WK9239 Item 28

To: D04 Main Members

From: Jim Roth, Task Group Chair and Jason Davis, Subcommittee Chair

Re: Proposed Type XI to D4956

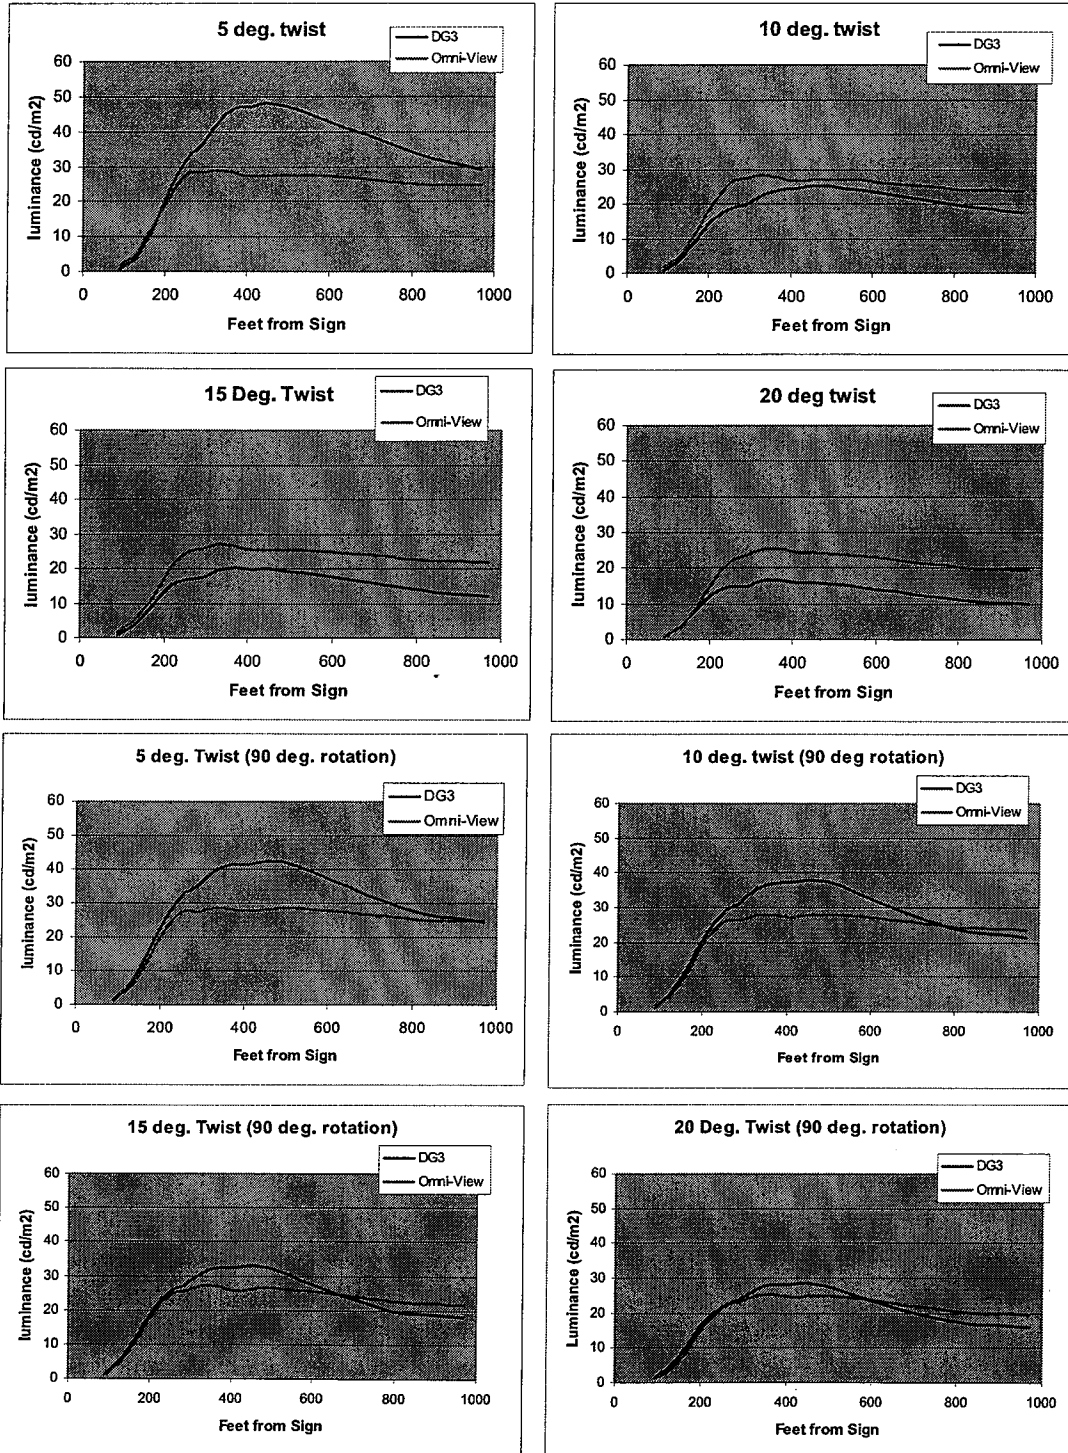
A new Type based upon a single product creates the opportunity for intentional or unintentional sole-source specifications. If someone wishes to only purchase a single, specific product – they may do so. They simply specify the product (and supplier) by name. We heard an example in Reno of a DOT that wishes to purchase DG³, and described that they need a Type XI added to D4956 to do so. This is not in accordance with federal procurement regulations. 49 CFR 18.36 requires that a purchaser justify their sole-source spec. It is only reasonable that we, as writers of a standard primarily used in purchasing agreements, apply the same criteria: we must see compelling evidence of a safety benefit.

It was also confirmed by multiple DOT officials in Reno that if ASTM D4956 adopts the current Type XI, few purchasers will recognize Type XI as a sole-source specification. This obviously creates the opportunity for deceptive purchasing practices. There is no good reason why we should create this opportunity for confusion. Also, as taxpayers, we should all be concerned when competitive price-pressure is removed from governmental purchasing decisions.

There has been no data presented that the values on the proposed table represent any particularly necessary or special level of performance. The only data that has been provided shows that DG³ is *perceptibly* different from other prismatics. This must not be misinterpreted as a measure of performance. A 10% difference in brightness may be discernable, but certainly does not constitute a meaningful safety benefit to the driver.

Remedy: If evidence of a compelling safety benefit unique to DG³ is presented and accepted by the subcommittee, then the existing table can be reconsidered. Or the table should be modified to accommodate additional products, which prevents the creation of a sole-source specification.
